National Committee on Uniform Traffic Control Devices

Proposed Language as approved by the NCUTCD on June 23, 2011, for new section on Pedestrian Channelizing Devices

TOPIC: Figure 6H-28 – Typical Application 28 Sidewalk Detour or Diversion

TOPIC: Figure 6H-28. Sidewalk Detour or Diversion (TA-28)

Figure 6F-XX Pedestrian Channelizing Device

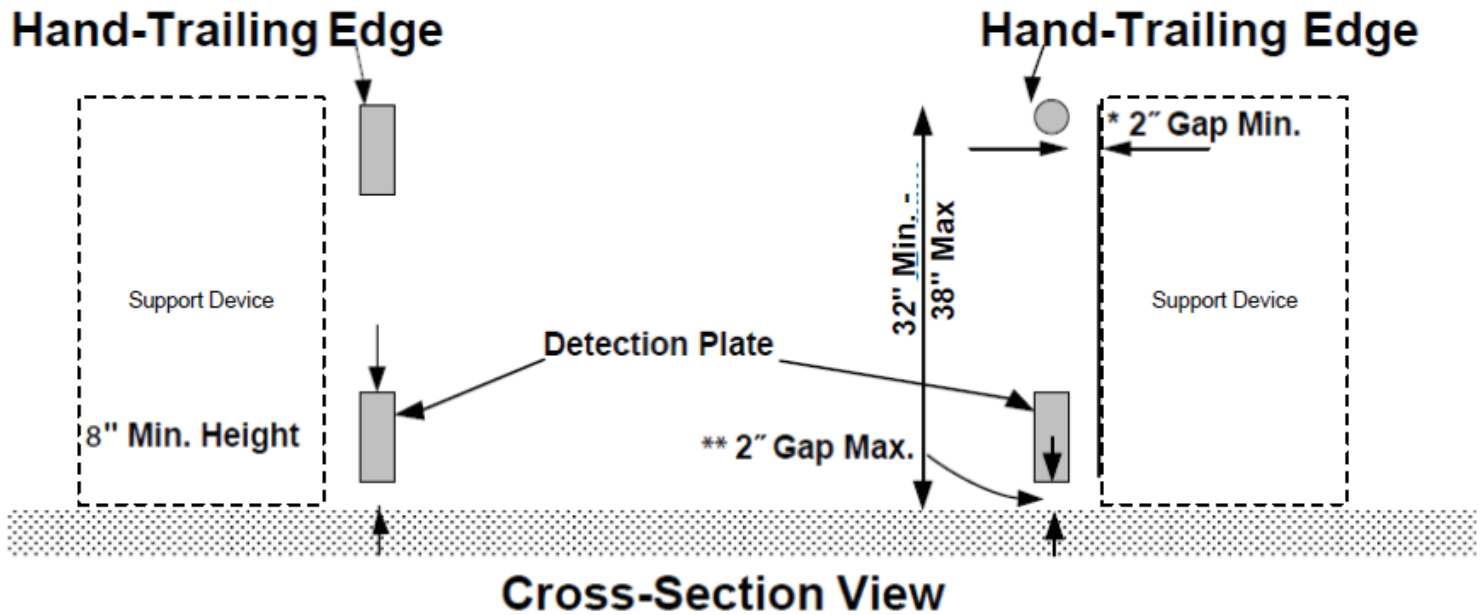
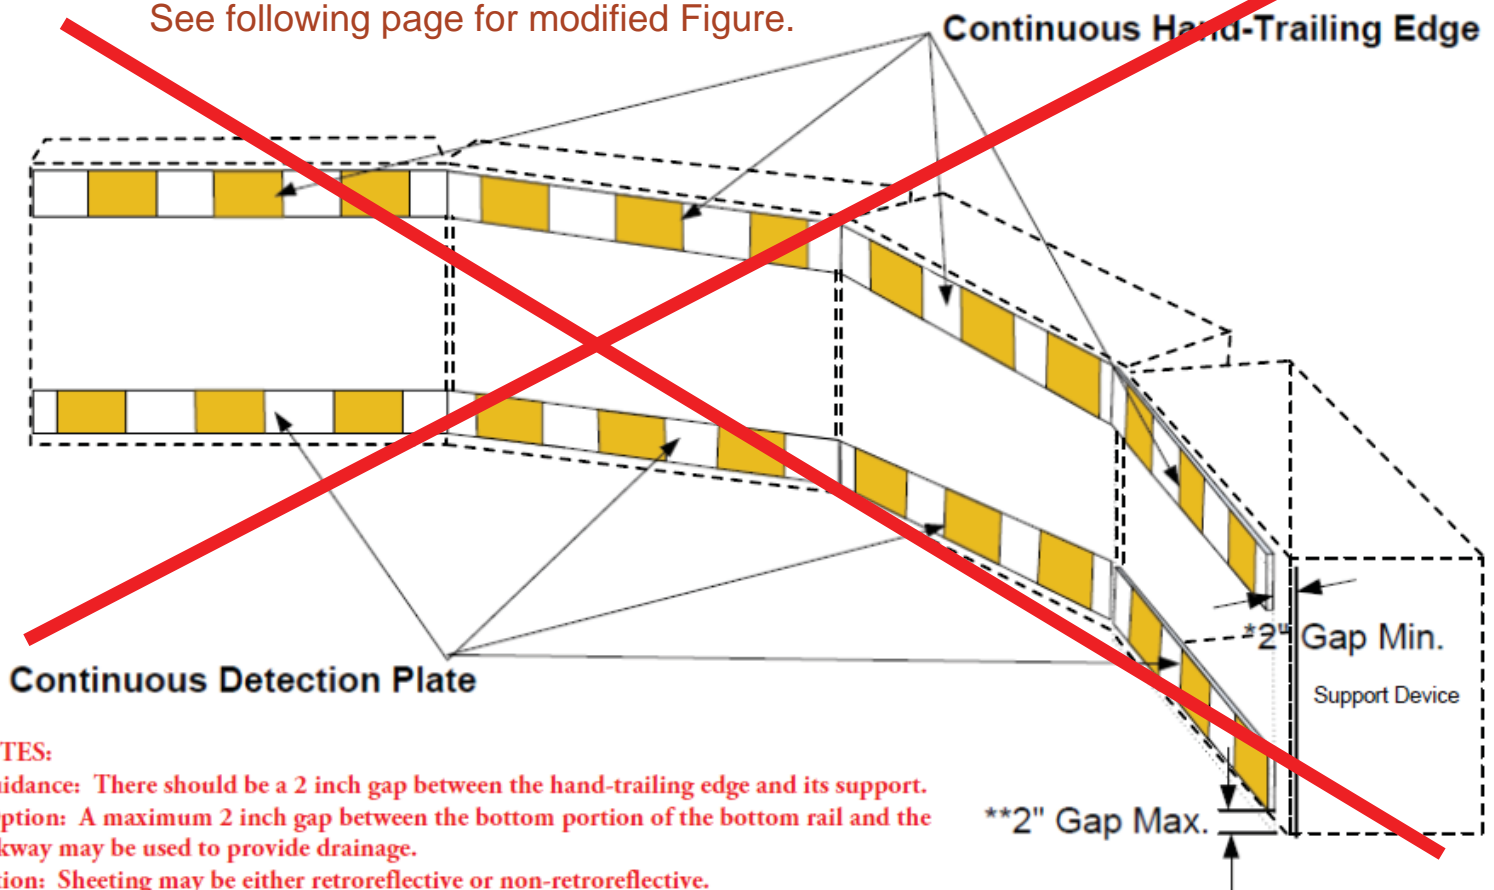
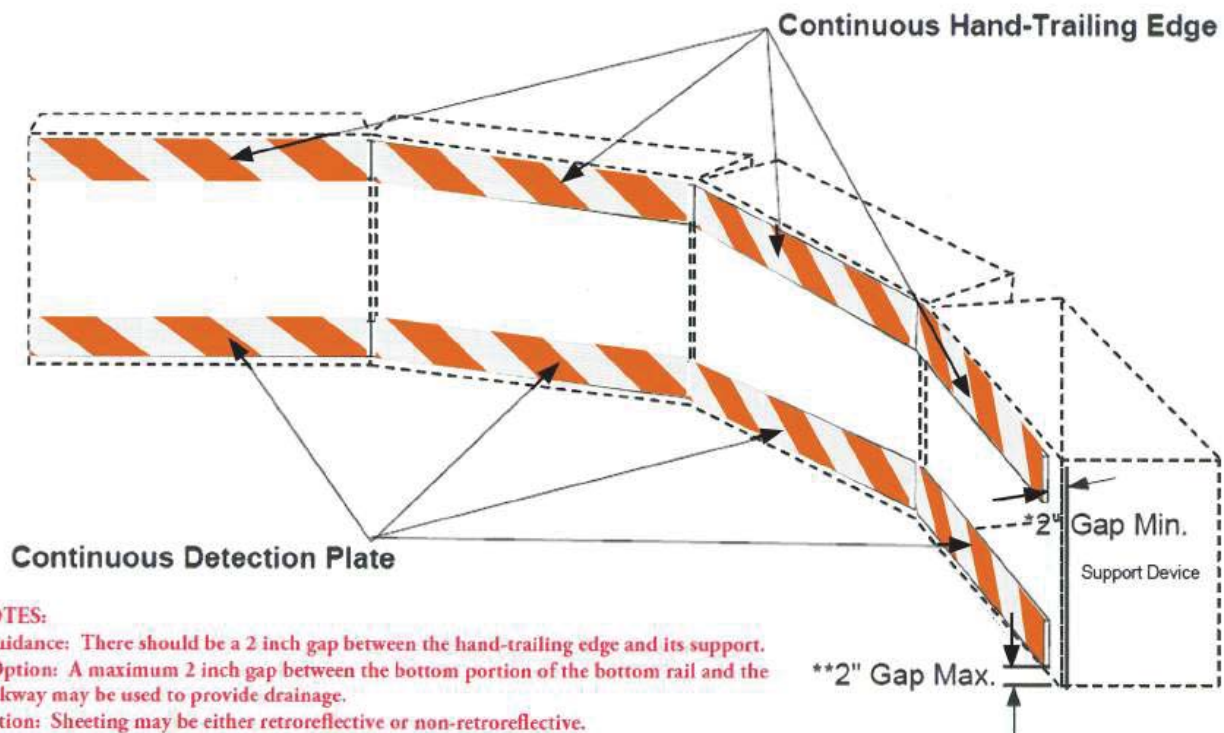
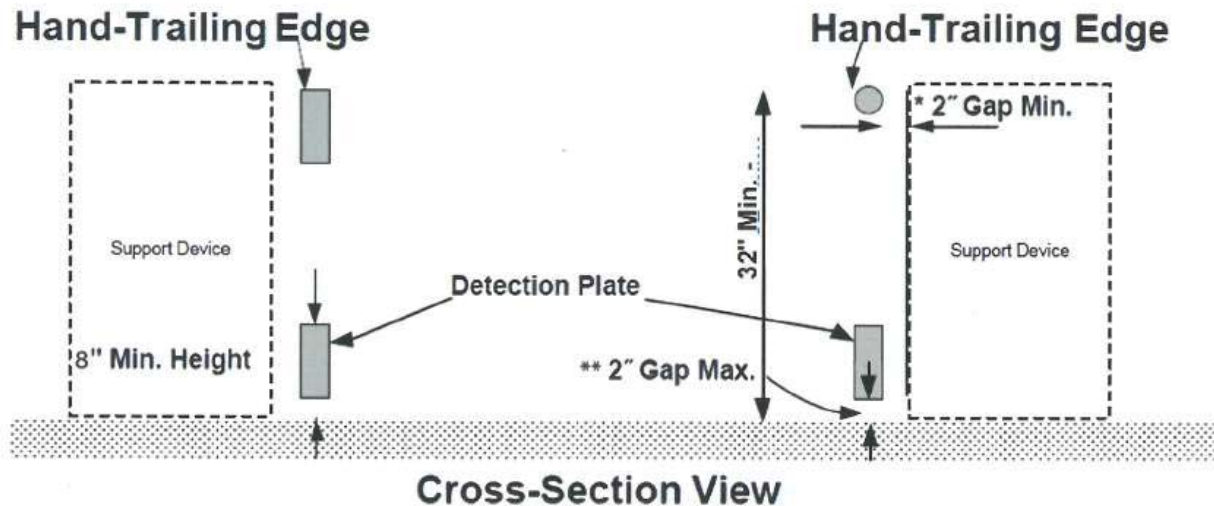
An editorial change to Figure 6F-XX, Pedestrian Channelizing Device, was approved by the NCUTCD Council at the General Session on June 10, 2016. The text of Section 6F.XX (below, page 3, line 2, allows the option of the sheeting facing the pedestrian side of the Pedestrian Channelizing device to have a vertical orientation. The Notes for Figure 6F-XX also allow the option for the sheeting panels to have either a vertical or a 45 degree angle orientation. Figure 6F-XX was modified to show the 45 degree angle orientation instead of the vertical orientation since this configuration may provide better guidance for low-vision pedestrians using the path around or through a work zone.

- 1 Option
- 2 The sheeting on the side of the device ~~fac~~ing-on the pedestrian side of the Pedestrian
- 3 Channelizing device may have sheeting with a vertical orientation.
- 4 Support:
- 5 The contrast of the light and dark stripes on the barricade sheeting assists low-vision pedestrians
- 6 in following the designated detour.

Modified 6-10-16 by Council General Session.
See following page for modified Figure.

Option: Sheeting may be either vertical or at a 45 degree angle.

Proposed Figure for TA-28

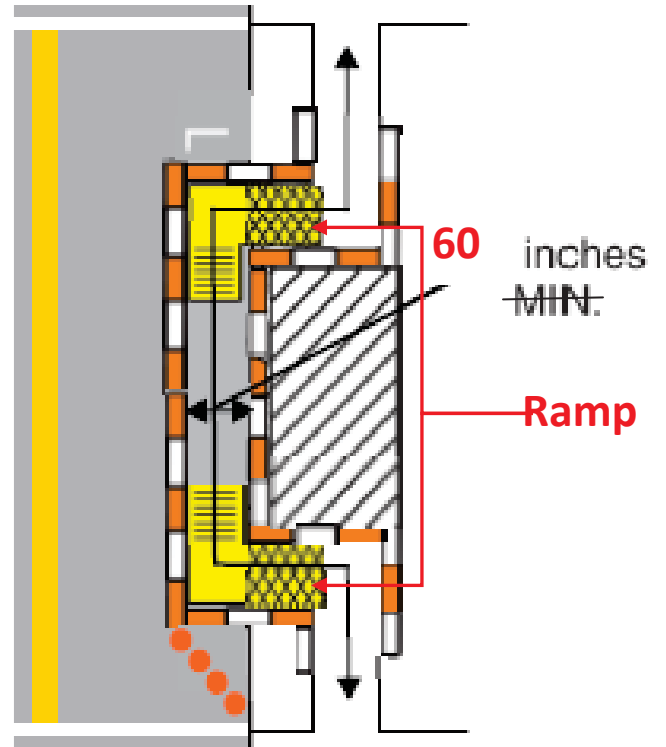
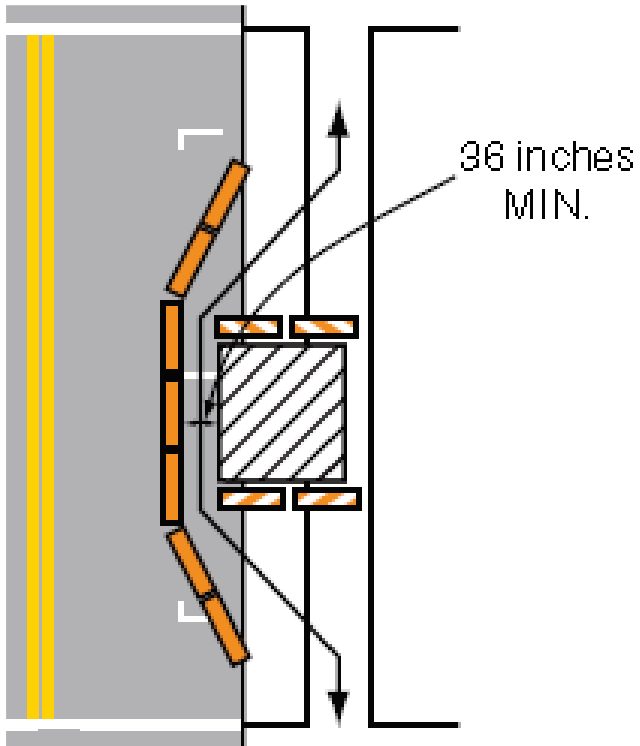
A practitioner recently contacted TTC to note a discrepancy between the Figure for Sidewalk Diversion and other sections in Part 6. Review of the practitioners comment showed several areas where this figure is not compliant with other sections of Part 6. The areas that are not compliant include:

- Lack of an accessible, detectable barricade between the pathway and the work space

- Use of a type 3 barricade to close the sidewalk which does not provide the detectability that Section 6.
- Use of the symbol for Longitudinal Channelizing Device to separate the alternate pathway from vehicular traffic without a note requiring that the LDC meet the detectability requirements of Section 6.
- Width of the alternate pathway is noted at 36 inches while Section 6. Requires 48 inch minimum
- Lack of notice to practitioners that a ramp is required when elevation changes by more than ½ inch.

Modify Figure 6H-28 Sidewalk Diversion to include longitudinal channelizing devices on both sides of the alternate pathway that are detectable to users of long canes and that have upper and lower rails as noted in 6.; adjust the width to read 48 inches minimum and depict ramps between the curb and the alternate walking surface. Modify the Notes to TA-28 to bring them into compliance with the 2009 Edition of the MUTCD and to support the modifications to the Figure. Include in the notes clarification of the use of temporary traffic barriers.

Modify the Figure in TA-28 as shown below:

113 [Note – add symbols in 6H-2 for ramp and pedestrian channelizing device]

Figure 6H-28. Sidewalk Detour or Diversion (TA-28)

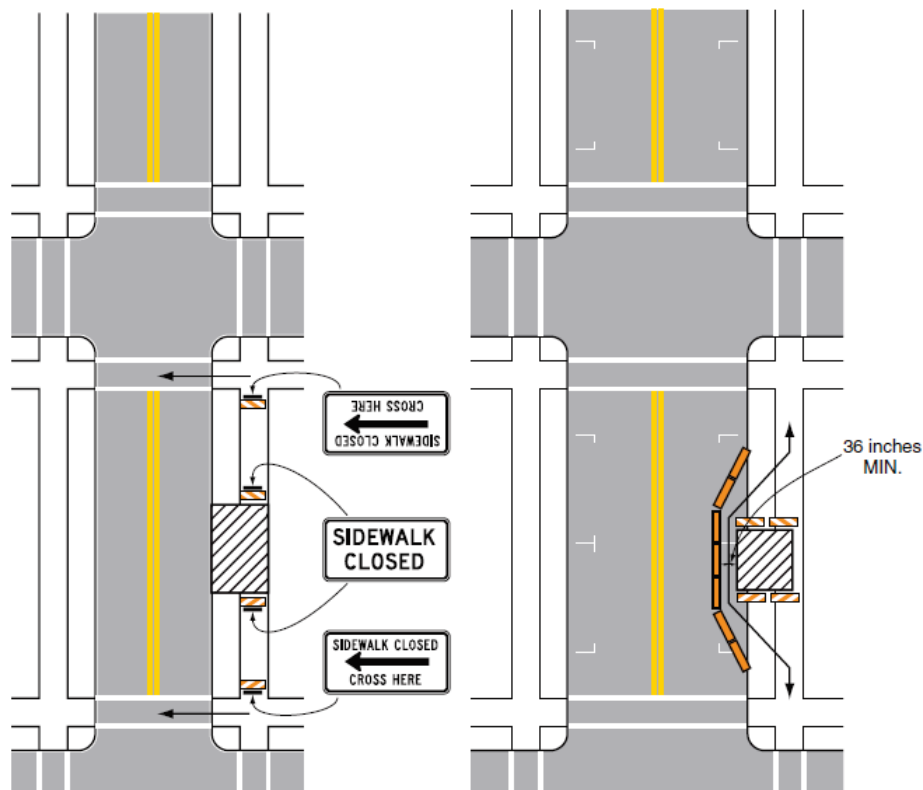
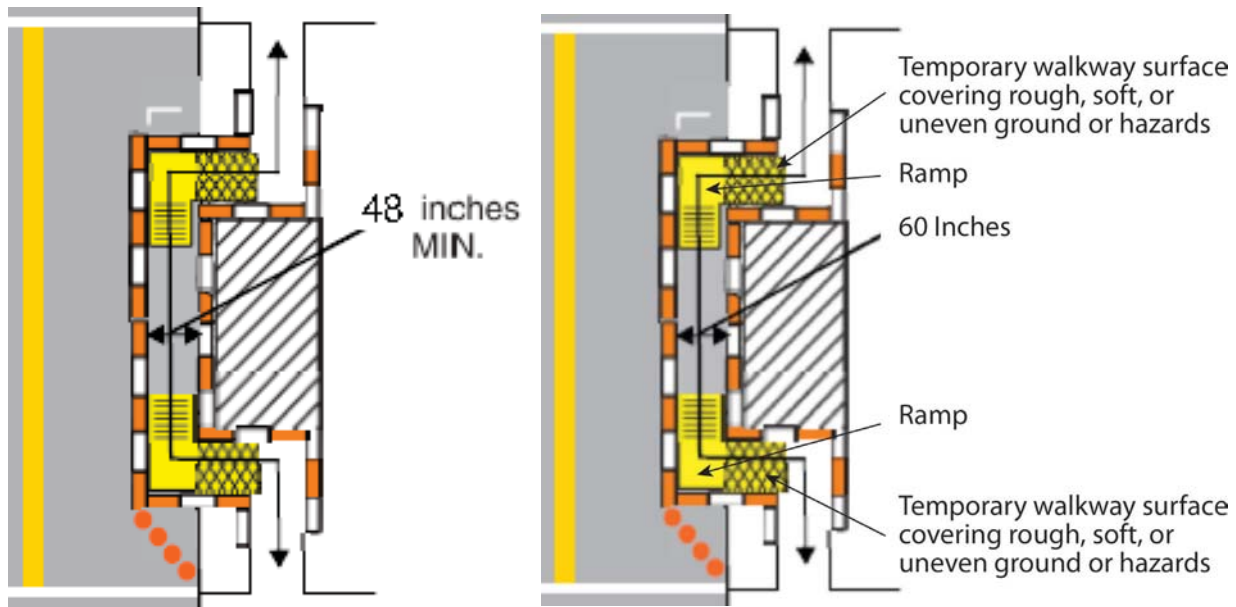
Revisions to TA-28 were approved by Council in June 2013. Sponsor comments indicated that several of the modifications were not clearly labeled. TTC agrees and made the noted clarifications on the drawing. These clarifications were approved by Council at the June 2014 meeting.

Because the revised figure includes the new elements of ramp and temporary walking surface, the notes are revised to address these elements.

Add the clarifications to the figure as noted below.

Clarification approved by Council June 2014
